UNITED STATES PATENT AND TRADEMARK OFFICE

APPLICATION NO.	FILING DATE	FIRST NAMED INVENTOR	ATTORNEY DOCKET NO.	CONFIRMATION NO.
09/745,074	12/20/2000	Nobuyuki Itoh	55506(840)	9273

## Office Action Summary

## DETAILED ACTION

**FIG. 27**

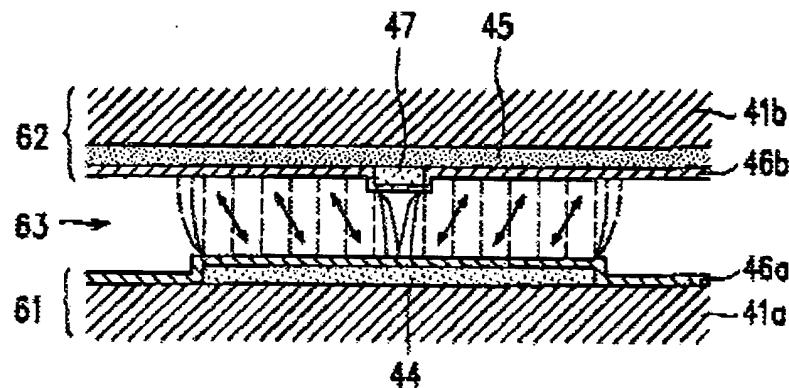
one of the at least one volume excluding member is provided on the at least one electrode on at least one of the pair of substrates, the volume excluding member being provided so as to be on at least a portion of one side edge of the at least one electrode (dashed rectangles in Figure 26); and the liquid crystal molecules are tilted in a uniform direction from the at least one side edge of the at least one electrode to an opposite edge when a voltage is applied to the at least one electrode (per double-headed arrows in Figures 22 and 27, col. 19, lines 9-19).

Hirata discloses zero tilt angle (col. 19, lines 1-8), which is parallel alignment that implies positive dielectric anisotropy, given the molecular alignments indicated in Figures 22 and 27.

**FIG. 26**

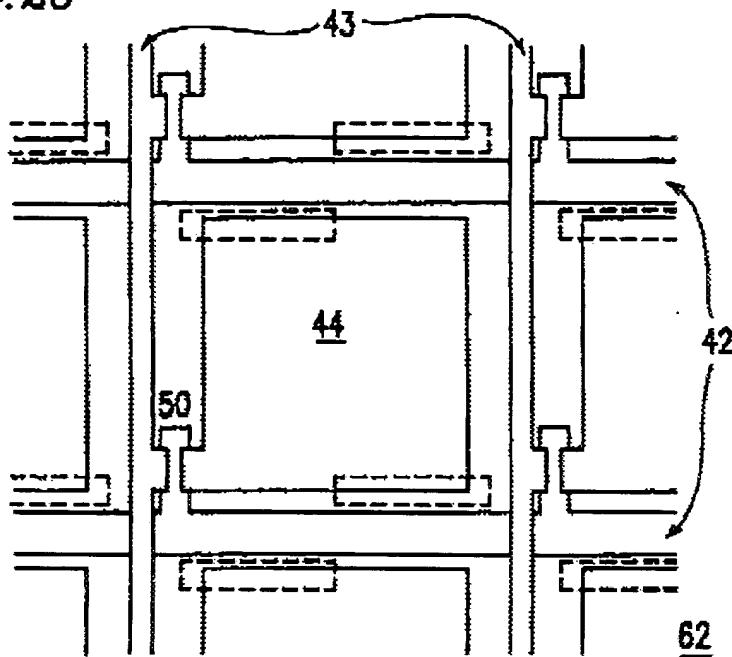
As to claim 4, Hirata in view of Colgan disclose the liquid crystal display as comprised above wherein: a plurality of volume excluding members provided on the at least one electrode on at least one of the pair of substrates, each of the plurality of volume excluding members being provided so as to be on at least a portion of each of an opposing pair of side edges of the at least one electrode but so as not to oppose each other (per dashed rectangles, Figure 26).

As to claim 5, Hirata in view of Colgan disclose the liquid crystal display as comprised above wherein: the at least one electrode on the at least one of the pair of substrates includes a first side edge and a second side edge; and the plurality of volume excluding members are provided along a portion of the first side edge and along a portion of the second side edge (per Figure 26).

**FIG. 25**

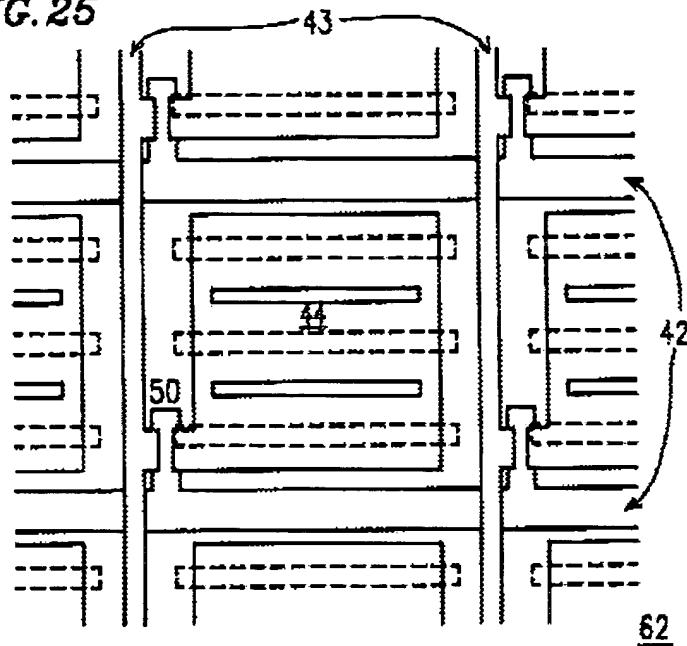
As to claim 6, Hirata in view of Colgan disclose the liquid crystal display as comprised above wherein: slit-like openings (Applicant's non-conductive window portion) (solid rectangles in pixel region of Figure 25) is formed in the at least one electrode on the at least one of the pair of substrates (col. 21, lines 27-32).

Hirata teaches the window openings may be interchanged with the volume excluding members (col. 21, lines 28-32). Hirata teaches that the addition of more pixel dividing members (adding more volume excluding members or non-conductive windows) provides a more natural looking effect to the eye of the observer (better picture).

FIG. 11(a)

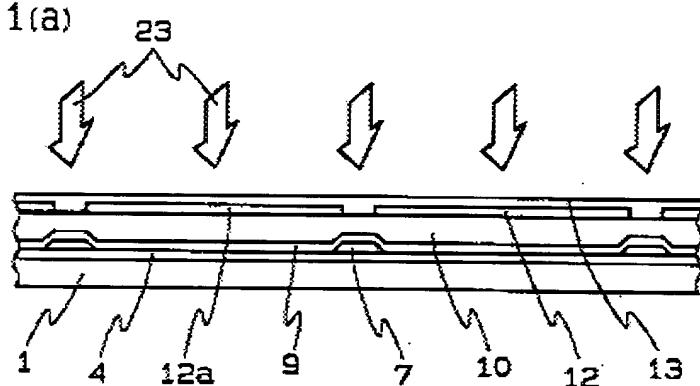
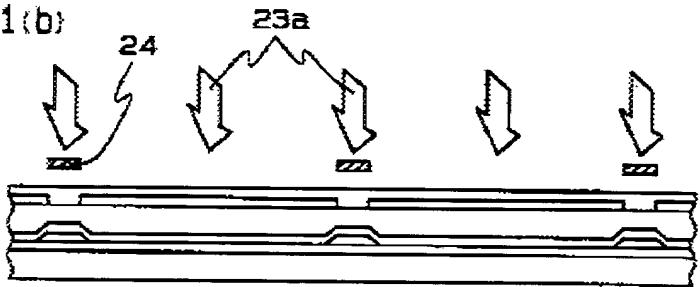
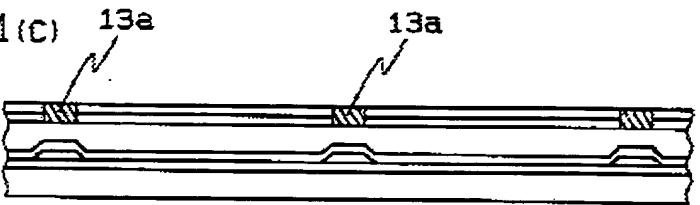
Numano teaches in Embodiment 3 (col. 11, line 35 through col. 12, line 5) and Figures 11(a)-11(c) the use of polarized ultraviolet light to weaken the strength of the alignment layer (reducing the vertical alignment to become more horizontal in alignment) in the region between pixels to reduce cross talk and allow for a higher

aperture ratio (col. 12, lines 3-5). The teachings and motivation of Numano expressed in 10 embodiments are considered to be robust to suggest the claimed invention to those having ordinary skill in the art of liquid crystals. Also, providing a direction of the horizontal alignment of the liquid crystal molecules in the at least one pixel portion is substantially identical to a direction of uniaxial horizontal alignment of the liquid crystal molecules in the non-pixel portion would be obvious to those having ordinary skill in the art of liquid crystals to prevent light leaks and thereby improve contrast.
